Access Compliance Report

Public Rights-of-Way

Intersection ID: 47576	Main Street: BARRANDS_LN	Cross Street: SEDGEBURN_DR	Location: SW
ADA ID: 479E95B5BD0E	Ramp Type: PerpDiag	Initial Pass/Fail: Fail	Overall Compliance: No
Severity Score: 13.75			
Codes/Mitigation Info/Possible Solution		Field Measurements/Component Compliance

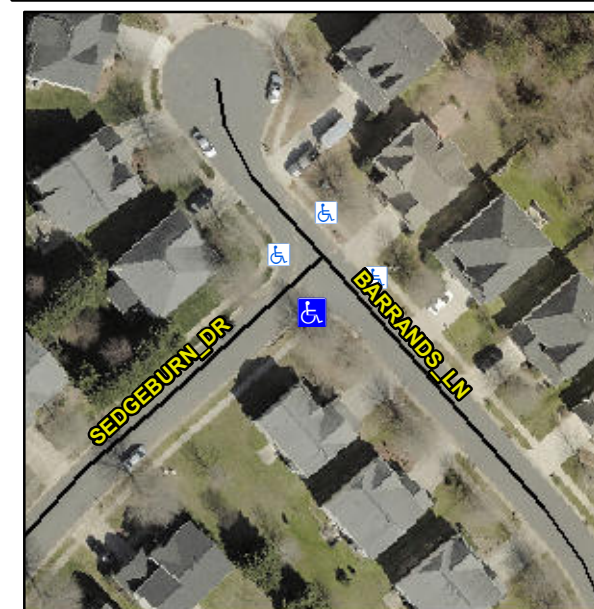
R304.2.2, R304.5.3

Compliance	Description	Data	Compliance	Description	Data
N/A	Ramp Length (in)	46.0	No	Ramp Slope (%)	10.1
Yes	Ramp Width (in)	48.0	No	Ramp XSlope (%)	3.3
N/A	Flare Type LT	N/A	N/A	Flare Type RT	N/A
N/A	Flare Slope LT (%)	N/A	N/A	Flare Slope RT (%)	N/A
N/A	Flare Traversable LT?	N/A	N/A	Flare Traversable RT?	N/A
N/A	Landing Length (in)	N/A	N/A	DWS Provided?	N/A
N/A	Landing Width (in)	N/A	N/A	DWS Contrast?	N/A
N/A	Landing Slope (%)	N/A	N/A	DWS Length (in)	N/A
N/A	Landing X Slope (%)	N/A	N/A	DWS Full Width?	N/A
N/A	Landing Curb? (Y/N)	N/A	N/A	DWS Offset (in)	N/A
N/A	Shared Landing?	N/A			
N/A	Gutter Ponding?	N/A	N/A	Gutter Slope (%)	N/A
N/A	Gutter Lip Ht (in)	N/A	N/A	Gutter X Slope (%)	N/A
N/A	Painted X Walk1?	No	N/A	Painted X Walk2?	No
	X Walk 1 Direction	To NE		X Walk 2 Direction	To NW
N/A	X Walk 1 Width (in)	N/A	N/A	X Walk 2 Width (in)	N/A
	X Walk 1 Slope (%)	0.7		X Walk 2 Slope (%)	0.3
	X Walk 1 X Slope (%)	2.4		X Walk 2 X Slope (%)	0.4

Remove & Replace Curb Ramp With Two New Directional Ramps or Equivalent.
